**Manitoba Minnesota Transmission Project**  
**Reducing Adverse Impact of Transmission, Line Capacity and Land Use**

**Presentation For**  
**Manitoba Wildlands**  
**Manitoba Clean Environment Commission**

**May 13, 2017**

Figure 6. Demonstrating how the tower height can be reduced for less obtrusiveness as well with a better appearance

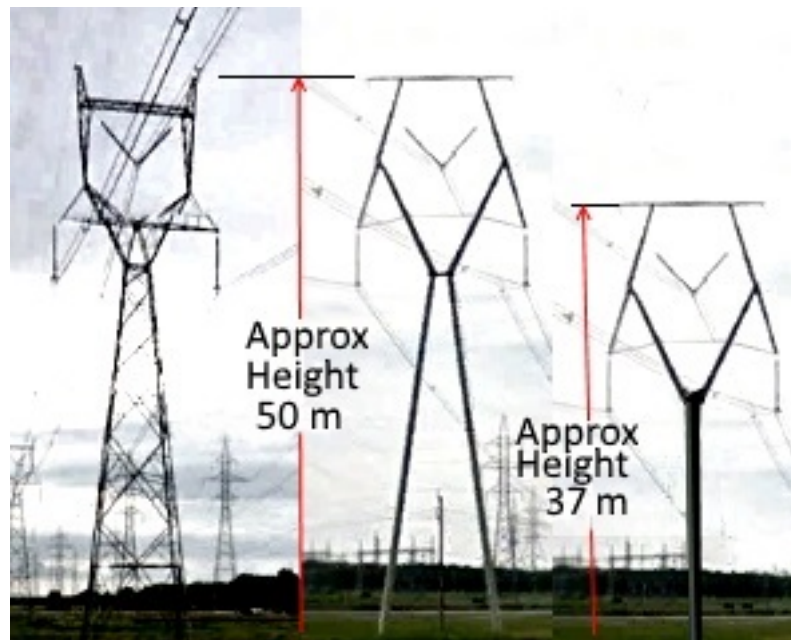
By lowering the height of the structures, the transmission line becomes less intrusive. By taking the aesthetic tower of Figure 5, keeping the same tower top, but lowering its total height by about 13 m, with the span reduced to keep the same conductor tension and mid-span clearance, a simple comparison of low profile versus the self-supporting steel lattice structure similar to what is designed for the MMTP is presented in Figure 6. This not a recommended low profile aesthetic tower design by any means, but is presented for comparison purposes only. A design similar to Figure 4 is better in appearance. With modern design techniques, materials and construction methods, the costs may come down as Valmont Utility Structures and Bystrup indicate is possible in Appendix C.

Assume the average height of the conductors at the lattice tower structures is approximately 35 m and 22 m for the lower profile tower of Figure 6 and the average mid span height for both is the same at 18 m (5 m greater than lowest conductor mid span clearance of 13 m - page 2-27 of reference [3]). The total average conductor height for the lattice tower structure and span is 23.7 m and 19.3 m for the low profile tower with reduced span.

Wind velocity increases with height above ground and so it can be approximately determined<sup>5</sup> that that the wind velocity at 23.7 m above ground is 3% greater than the wind velocity at 19.3 m above ground for open land surfaces. So indeed the lower profile transmission system design benefits slightly from lower wind forces. This percentage will increase when the transmission line is through forest with a narrower right of way.

So in plain and simple terms, the line with a shorter tower will be exposed to a lower wind force. Therefore a shorter tower is less impacted by wind load. It

Figure 11: Presidential Permit for the Great Northern Transmission Line (MMTP)

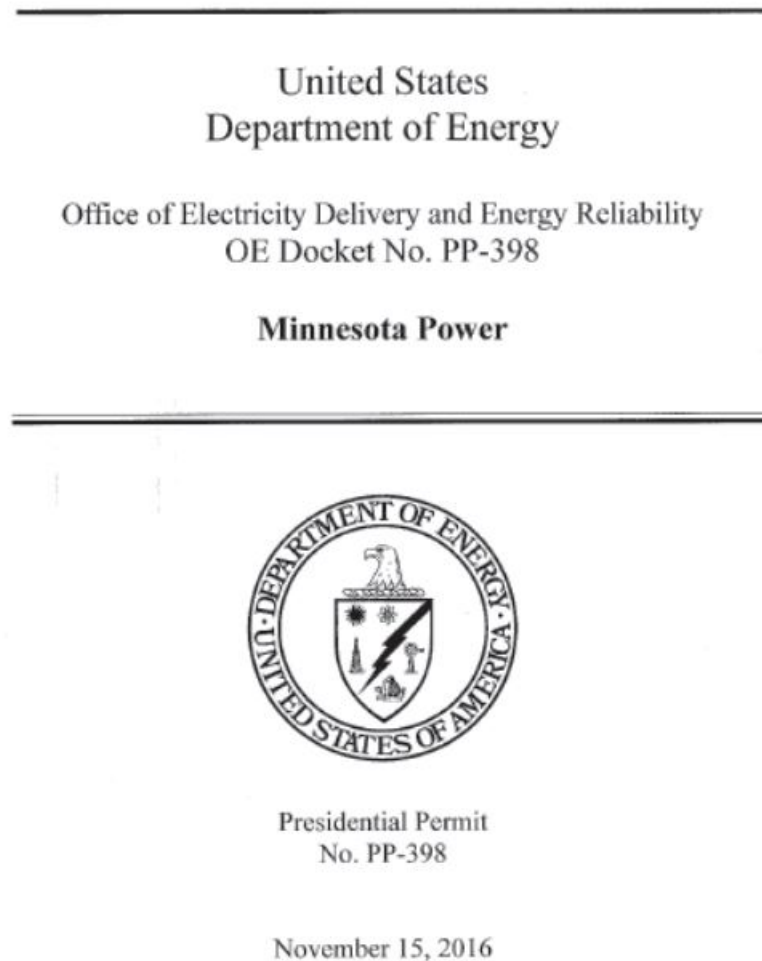
From Question # DPWO-IR-010 we learn that Presidential Permit # 398, issued November 15, 2016 indicates a not to exceed level for Manitoba Hydro to purchase 750MW of winter capacity from Minnesota Power while not to exceed the delivery of 883 MW of summer capacity to Minnesota Power.

The fact that winter energy can be provided from Minnesota Power up to the 750 MW to be delivered to Manitoba, there is no obvious need for Manitoba to contract to purchase to this level when Bipole III and Keeyask are able to supply all the winter supply Manitoba needs. This

According to Presidential Permit # 398, Manitoba Hydro can supply up to 883 MW of power for summer export energy to Minnesota Power. Much depends on what actual contract level for summer power and energy south is agreed upon. No doubt Manitoba Hydro will have the generating capacity for north to south exports. Based on the expected summer power contracted south to Minnesota Power, will there be enough capacity on MMTP at 230 kV along with the existing interconnection to Minnesota Power to deliver this amount without resorting to a 500 kV, 1500 MW interconnection?

The Presidential Permit # 398 is not cast in stone. There is possibility to change the requirements of the Presidential Permit # 386 with the approval of the US Department of Energy.

Figure 14: Demonstrating how transmission line swing-out from wind contributes to width of ROW

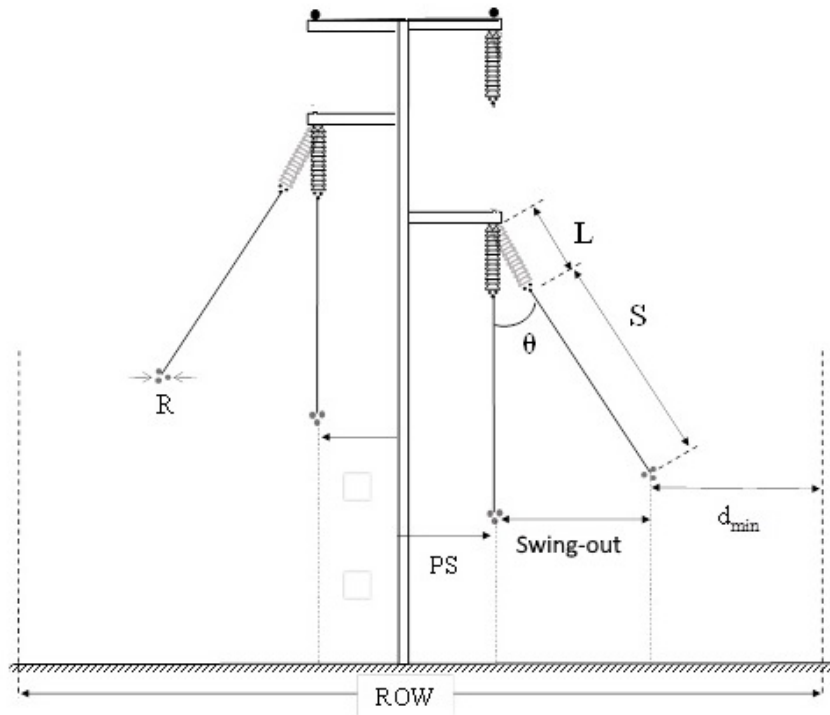
Conductor swing-out is shown in Figure 14. Swing out is less with a shorter span, resulting in the possibility for a reduced ROW width. By way of example, for the designed MMTP line of chapter 2 in the EIS with a 400 m span but not knowing the exact parameters used by the transmission line designers of Manitoba, the swing-out is approximately 32 m based on assumed values. A shorter 250 m span would have an approximate swing-out of 15 m, a difference of 17 m. Taking into account both sides of the of the transmission line, this provides opportunity to reduce the ROW by 34 m. Thus the ROW width could be reduced in the extreme to  $80 - 34 = 46$  m. With tubular steel tower structures located where ROW is 100 m, the possible ROW reduction is much more dramatic.

In forested areas shorter spans and reduced conductor swing-out require fewer trees to be cut and more carbon dioxide sequestered from the atmosphere. It also saves maintenance costs related to regular clearing under the lines. In such areas, the cost of footings increases less rapidly with height, particularly if the average conductor height is at tree level or lower. In agricultural areas, smaller corridors reduce the economic losses due to future value of land, land income, harvest losses and the time and cost of cleaning out weeds. These are benefits of the resulting narrower ROW.

Figure 15: Lattice tower and low profile structure comparison

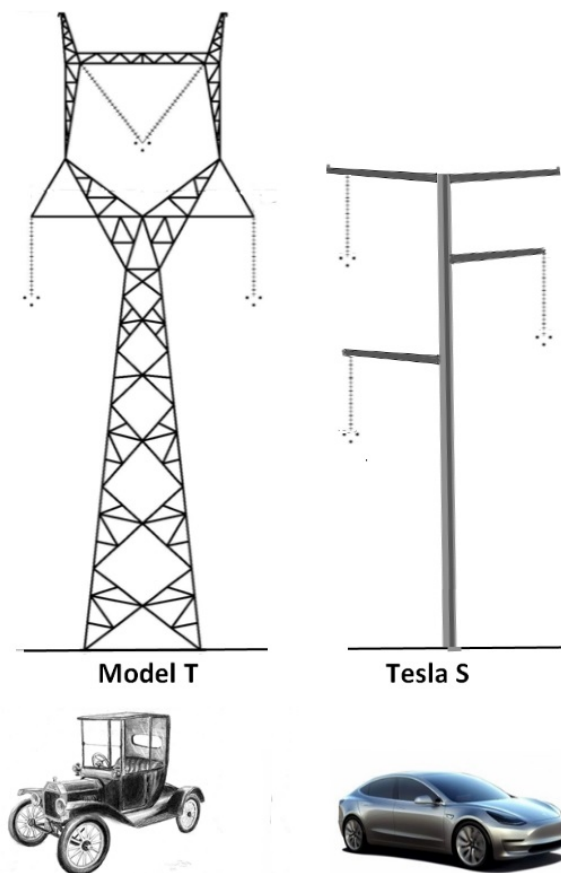
In IR#2 MWL-IR-087 we stated that there is a 100 square metre footprint of an MMTP tower on crop land, an area prone to weeds once every 400 metre span length, whereas a tubular steel low profile tower would have a much smaller footprint of about 5 square metres every 250 metres with minimal weeds to deal with.

Since landowners were not consulted on the transmission line design, the assertion that the large 400 metre span with its 100 square metre footprint is less an obstacle than the 250 m span with tubular steel low profile tower and a much less 5 square metre footprint is not a convincing justification.

We can only assume that landowners are not aware of any alternative configurations that may be available and so did not question what Manitoba Hydro presented to them in the EIS chapter 2. Is it the landowner's responsibility to be up-to-date on the latest and developing technologies of high voltage electric power transmission or is it Manitoba Hydro's?
